P5022A-03B-S

Safety Service Note

P5022A Keysight Streamline USB Vector Network Analyzer

“POTENTIAL BURN INJURY (HIGH TEMPERATURE) HAZARD”

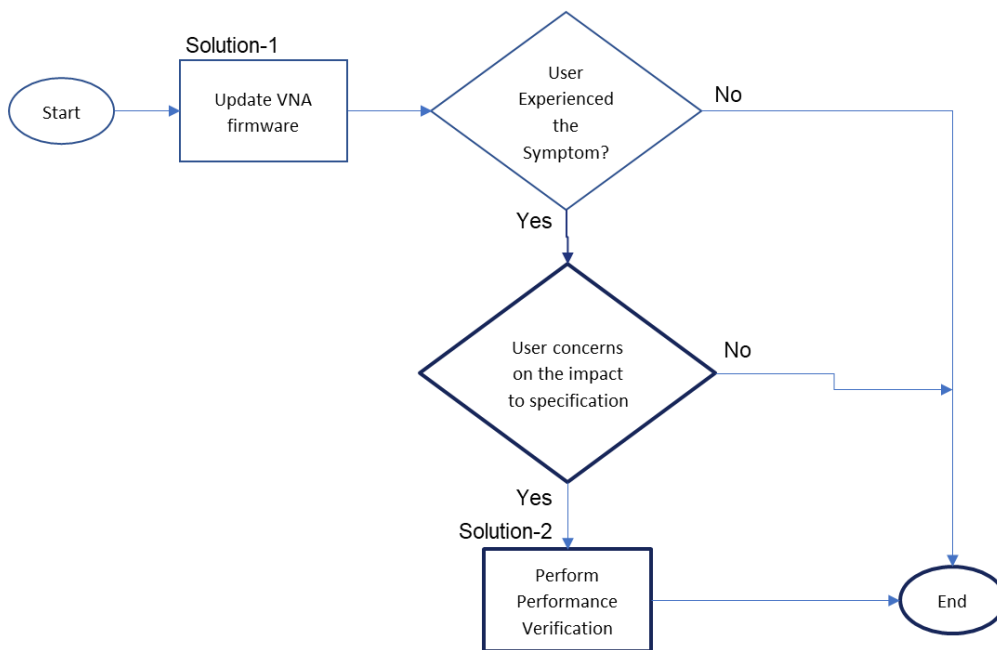
VNA fails to start with the following symptoms.

- 1. LED indicator (below circle) turns red.
- 2. cooling fan does not work
- 3. If user leaves the VNA with this LED indicator red without turning off power switch, it continues to overheat and becomes too hot.

Solution-1: Update VNA firmware by user

Action-1: Updating the firmware eliminates this potential risk of overheating.

1. **Install the latest VNA firmware Rev. A.15.40.13 or newer** on users' controller PC(s).
The latest firmware enhanced the thermal fan control mechanism.
2. Once the latest firmware is installed, proceed with the restart of both **controller PC** and **VNA**.
3. Launch the VNA firmware. Ensure VNA powers up and launches into firmware correctly after firmware update is done.
